# REPORT ON SAFETY AUDIT OF PUNE SATARA ROAD BETWEEN SWARGATE AND KATRAJ JUNCTIONS

ADDITIONAL CITY ENGINEER (BP & DP)  
PUNE MUNICIPAL CORPORATION

Creations Engineers Pvt. Ltd. and Pavetech Consulting  
Engineering Services Pvt. Ltd.

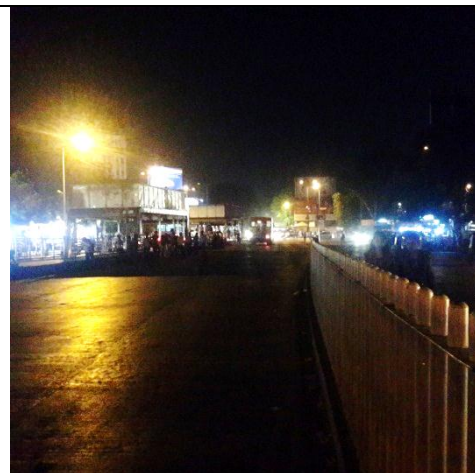
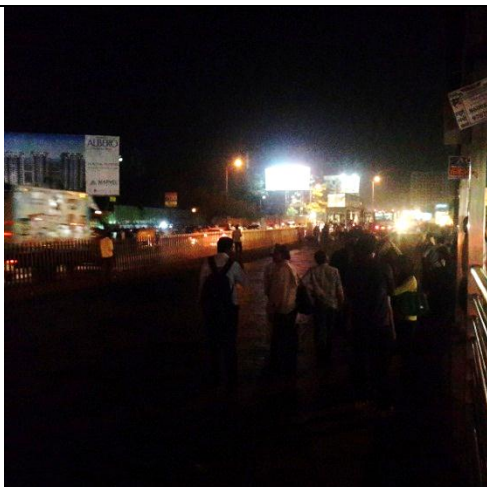
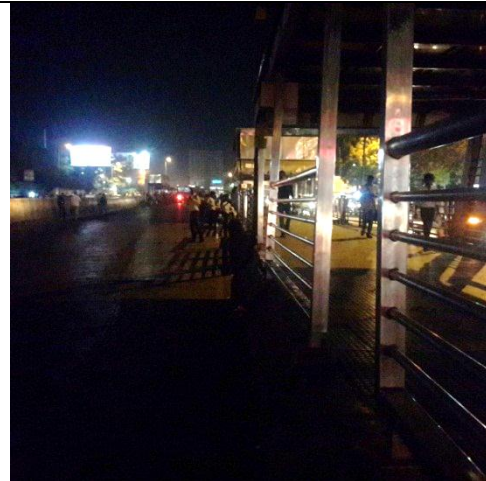
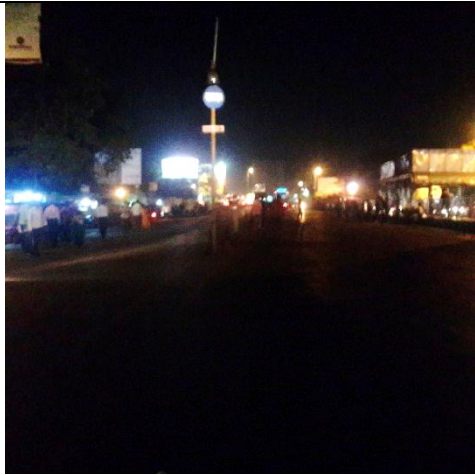
Chainage 1/500 RHS side 18.462140, 73.858245: Discontinuous cycle track and footpath between Dhankawadi Bus route and BharatiVidyapeeth need to be urgently rectified/ restored.

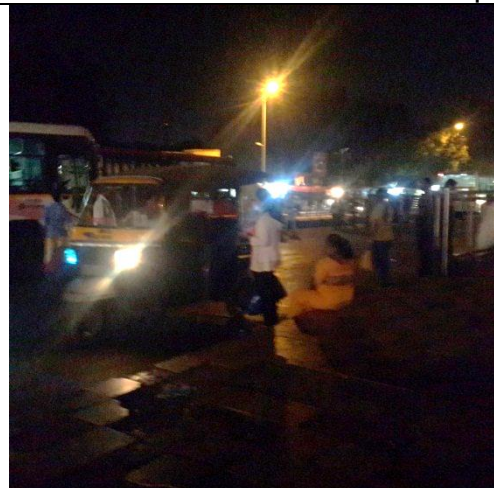
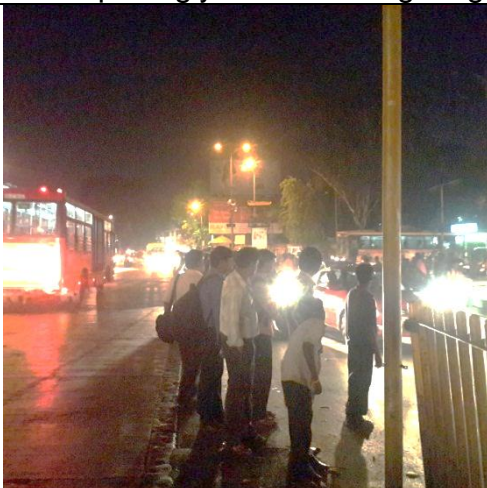
Chainage 2/450 LHS side 18.469223, 73.857194: Difference of 40 -50 mm in longitudinal direction (gaps) in the main carriageway leads to skidding of the two wheelers and needs to be rectified urgently.

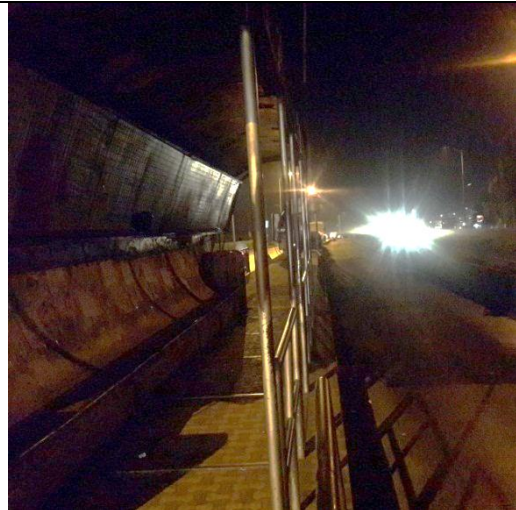
Swargate junction Chainage 5/800 m 18.498676, 73.858310– Removal of channellization island, wide road width, poor illumination and lack of traffic signal creates a chaotic situation in front of Swargate Bus depot entrance putting two wheelers and pedestrians at high risk of physical injury. The lighting arrangement at the edge of the ROW is inadequate to illuminate the ROW and BRTS corridor. Street light poles are installed at the extreme edge of the ROW. BRTS is partially functional and buses going towards Katraj from the bus stop move at high speed when entering the intersection.

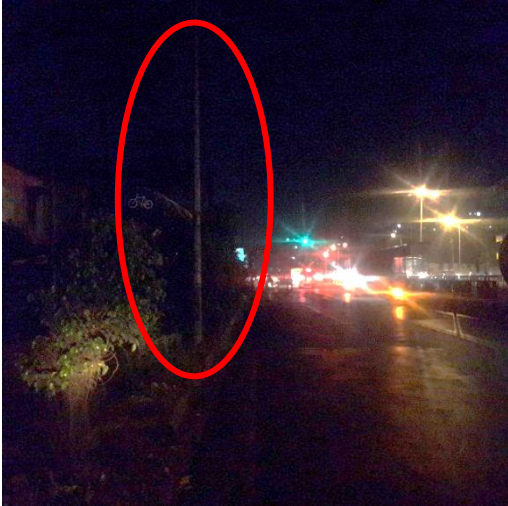
Chainage 3/600 m and 3/700 m RHS side 18.481847, 73.857473: The thermoplastic painting at road edge, between lanes in the BRTS corridor as well as main carriageway is faint/faded and lacks adequate reflectivity.

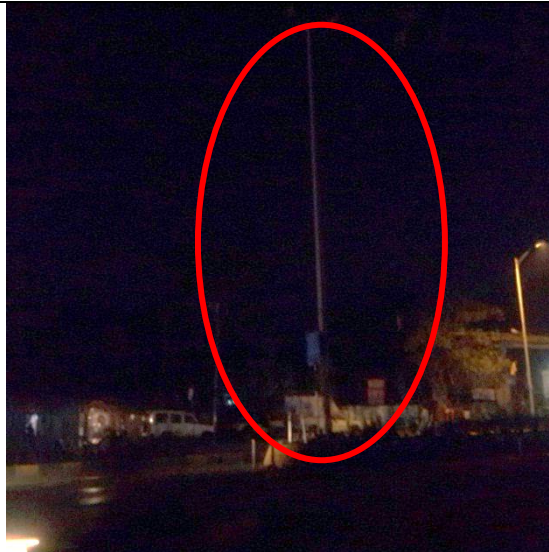
Chainage 4/800 m and 3/700 m LHS 18.478082, 73.857344: BRTS bus stop near Market Yard Junction and near Padmavati junction lacks any lighting arrangement. The BRTS corridor also lacks any street lighting arrangement thereby putting pedestrians to risk when crossing the road during night time.

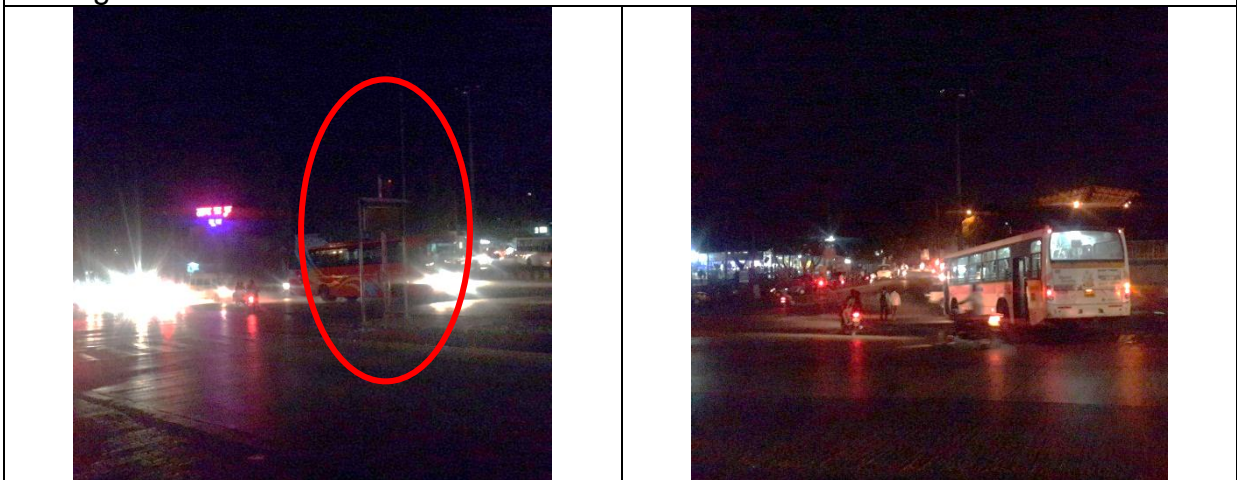
Chainage 2/700 RHS side 18.464080, 73.857805: Addition of reflectors, blinkers along the construction barricading to offset the poor lighting arrangements is urgently necessary.
